Memo – Ara Hills Response

Subject: – Delmore Stage 1 and 2, Russell Road, Orewa

We have reviewed the memo from Ara Hill' engineers, and respond as follows -

Figure 2 - Finished contour plan, Ara Hills.

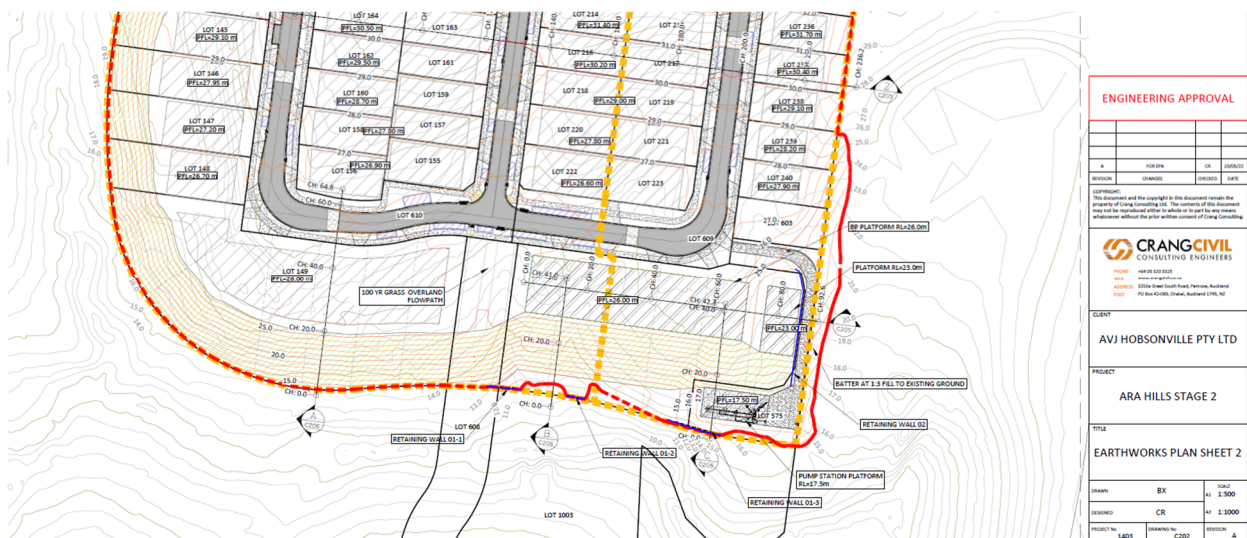
- 1) A flat building platform, with Finished Floor Level's shown on the approved plans, shown below in **Figure 2** at approximately RL 26.
- 2) A 1 in 1.5 (66.6%) reinforced mass-stablsed slope.

The two areas are clearly visible in **Figure 2** below, with the flat building platform (RL 26) area being devoid of contours and the batter slope having close contours, indicating steepness.

Figure 3 - Cross section A-A, showing Flood level calculated by Airey Consultants Ltd

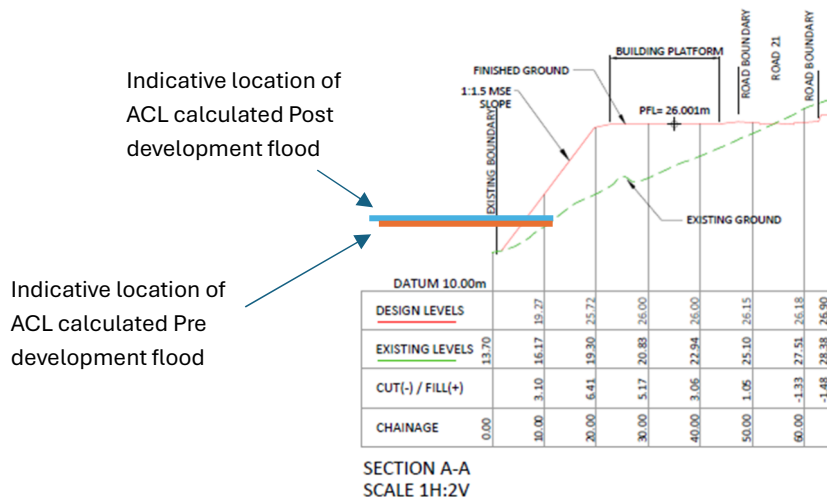
Cross section A-A, which corresponds to 'A-C205' in **Figure 2** is provided below in **Figure 3**, clearly showing the building platform.

The bottom of these slopes are at approximately RL 13 – 15m as mentioned in the report. Given the flood level is approximately 16.34RL (Ara Hills) it would practically only be the toe of the embankment being submerged. This information shows that the statements made by Mr Roberts are incorrect. There are no building platform areas located at RL15m, as suggested by Mr. Roberts. The lowest building platform area within this area of site is RL23m, as shown as a hatched area below in Figure 4.

Figure 4 - Lowest Platform Level = R23.0m

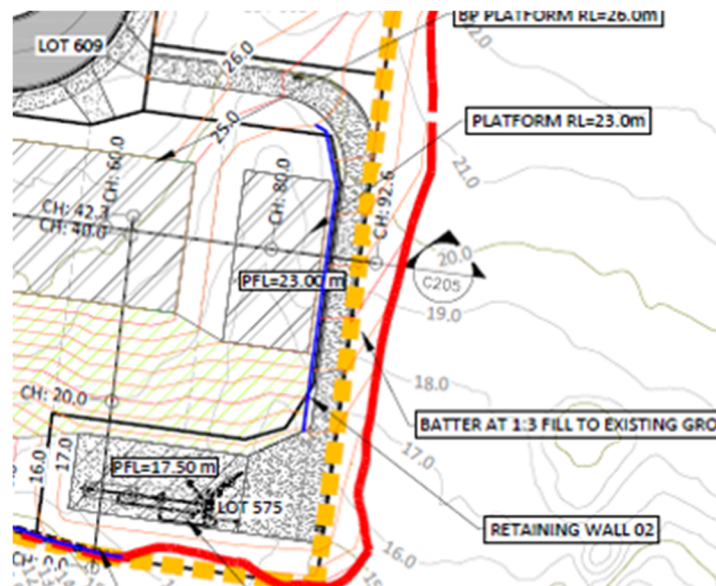
Upon review of the Ara Hills cross-sections, it is considered that this statement is misleading with regard to the potential for future development within these areas. Mr. Roberts is suggesting that the batter slope areas as shown in **Figure 4** above (with gradients of 66%) could be developed with patios, decking, or swimming pools.

Figure 5 - MSE reinforced embankment

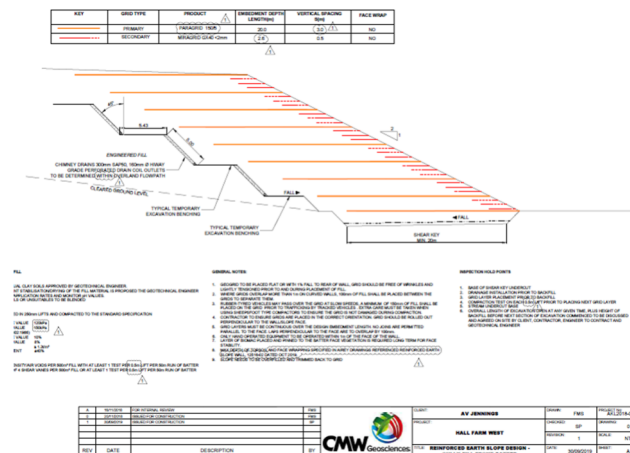
McKenzie & Co refute the reality of this statement. Given the steep slope grade of 66%, and the presence of geogrid through the embankment, the notion of these slopes being used for the above purposes is unrealistic. It is considered by McKenzie & Co that this statement by Mr. Roberts is overstating both the risk associated with the existing flood plain and the minimal increase of this flood plain generated by the Delmore development (in the order of 140mm, as elaborated further below).

Figure 6 - Ara Hills proposed flood plain map, 2021

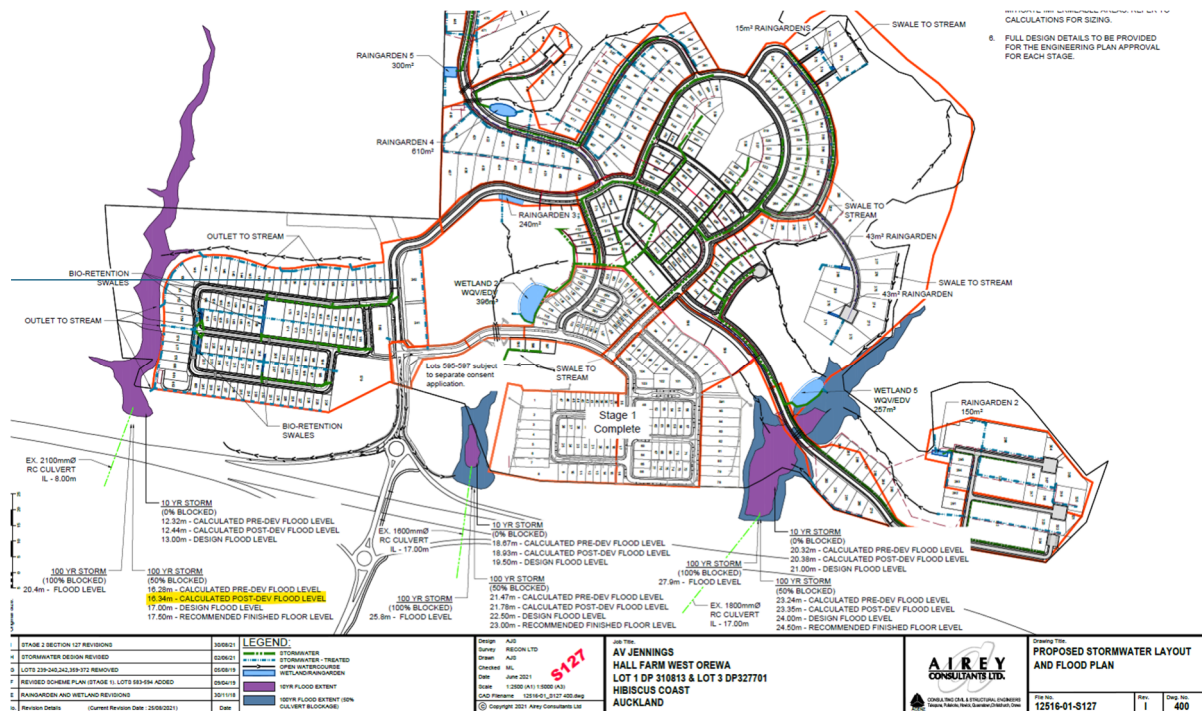
The flood levels have been calculated by Airey Consultants Limited, as part of the resource consent process for Ara Hills, which shows that the calculated flood depth for the pre-development flow, is 16.28m, and the post Ara Hills development scenario is RL16.34m. This is an increase of 60mm.

Nonetheless, the Ara Hills plan shown below as **Figure 5** shows that in both the pre and post development scenarios, the flood plain increases from 16.28m, to 16.34m as part of the Ara Hills development, and the lower parts of the lots identified by Mr. Roberts are flooding already in both scenarios.

There is an increase in flood levels resultant from the development of Delmore, however, it is not inconsistent with the existing flood hazard that exists on the site, based on the Ara Hills flood report, as the flood hazard already exists.

The modelled increase of 140mm at the Ara Hills lots does not increase the flood risk to habitable floor levels or increase flood risk to pedestrian or vehicle egress or other activities, and therefore we stand by our assessment that the flood risk to Ara Hills is low.

Figure 7 - Pumpstation flood protection wall

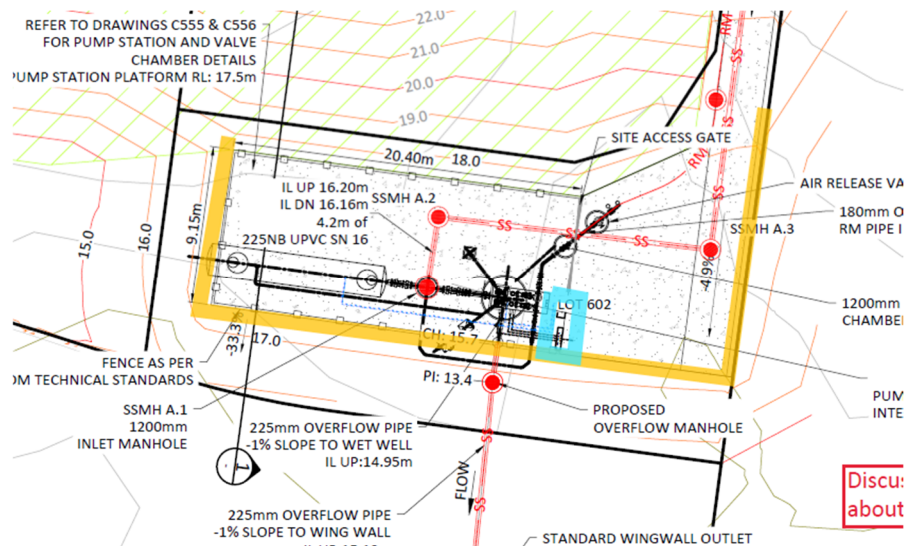
The Ara Hills pumpstation level (as seen in **Figure 2**, further above) is already prone to flooding in the Delmore pre-development scenario, when McKenzie & Co apply the latest climate change data. The finished level of the pumpstation is RL17.5m AUK1946, which is 17.2m in NZVD. The existing flood level (pre-development of Delmore) is 17.17mRL, so based on the latest climate change data, the existing Ara Hills pumpstation does not have the required freeboard. Therefore flood risk already exists, it is not a product of the Delmore development.

The minor 140mm increase in flood level created by Delmore doesn't introduce a new flood risk, as the pumpstation site is modelled as already non-compliant in the pre-development scenario. In our experience the Ara Hills consent holder will already need to be looking at remediation works given the current risk profile, which Delmore does not create.

A simple remediation which the Ara Hills developer might consider would be to construct a small flood protection wall within the pumpstation site, approximately 300mm high, either just around the water sensitive electrical gear shown in blue, or the full site shown in yellow (refer to **Figure 6**, below).
